# UNITED STATES PATENT AND TRADEMARK OFFICE

APPLICATION NO.	FILING DATE	FIRST NAMED INVENTOR	ATTORNEY DOCKET NO.	CONFIRMATION NO.
10/569,317	02/22/2006	Jiecai Gan	NFE105	7888
56352	7590	11/02/2009		
GLOBAL IP SERVICES 7285 W. Eagle Court Winton, CA 95388			EXAMINER  YOUNKINS, KAREN L	
			ART UNIT	PAPER NUMBER
			3751	
			MAIL DATE	DELIVERY MODE
			11/02/2009	PAPER

## Office Action Summary

## **DETAILED ACTION**

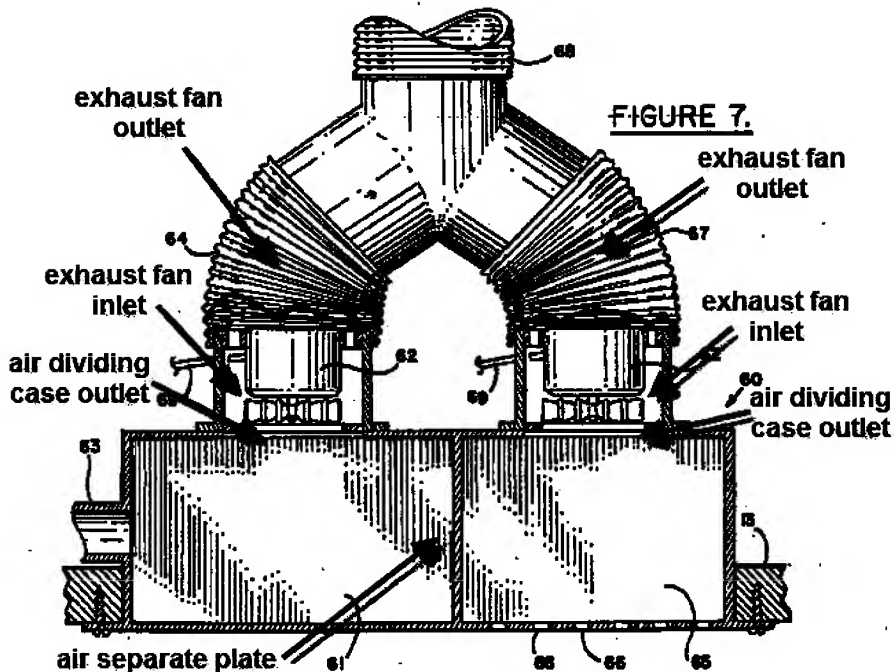
12. Claim 13 recites "the exhausting apparatus is installed on a ceiling of the toilet". This limitation renders the claim unclear. The examiner is unaware of any art specific meaning of a ceiling on a toilet, nor is one defined in the specification. Further, as depicted in figure 1 the exhausting apparatus of the present invention is disclosed as being installed on a ceiling of a room housing a toilet, not on a toilet.

16. With reference to claims 11-13, and 23, Prisco discloses, with attention drawn particularly the embodiment disclosed in figure 7, an exhausting apparatus with an air dividing case (surrounding compartments 61 and 65) for a water closet (10) comprising an air dividing case having an inner chamber (61/65) with an outlet (see examiner annotated drawing above) and an inlet (via 63) connected with a water closet (see column 4 lines 12-14). The exhausting apparatus also includes an exhaust fan (62) with an outlet and inlet connected with the outlet of said inner chamber (see examiner annotated drawing above). The outlet of the exhaust fan is connected to the outdoors

through a duct (67), see column 4 lines 16-22. Further, Prisco discloses the inner chamber having through holes via the screened openings 66. The screen/'lid' covering the openings is 'moveable' on and off of the openings. The inner chamber has an 'air separate plate' inside of it, see examiner annotated drawing above. The 'air separate plate' divides the inner chamber into two chambers (61 and 65) such that one chamber (61) leads to the water closet (10). Prisco also discloses the use of the 'air separate plate' dividing the inner chamber into dual compartments may be required in rooms having a plurality of toilets, see column 4 lines 22-24. Further, the outlet is separated by the air separate plate into two parts to the extent claimed, the through hole opens to the toilet 'directly', and the apparatus is installed on a ceiling of a room housing a toilet (see figure 1).

13. As best understood and for the purposes of examination, the examiner assumes that the 'through holes' connect the air dividing case to the air within the room containing the toilet and/or water closet(s), and that the exhausting apparatus is installed on a ceiling of room housing a toilet. The claims are examined as best understood.
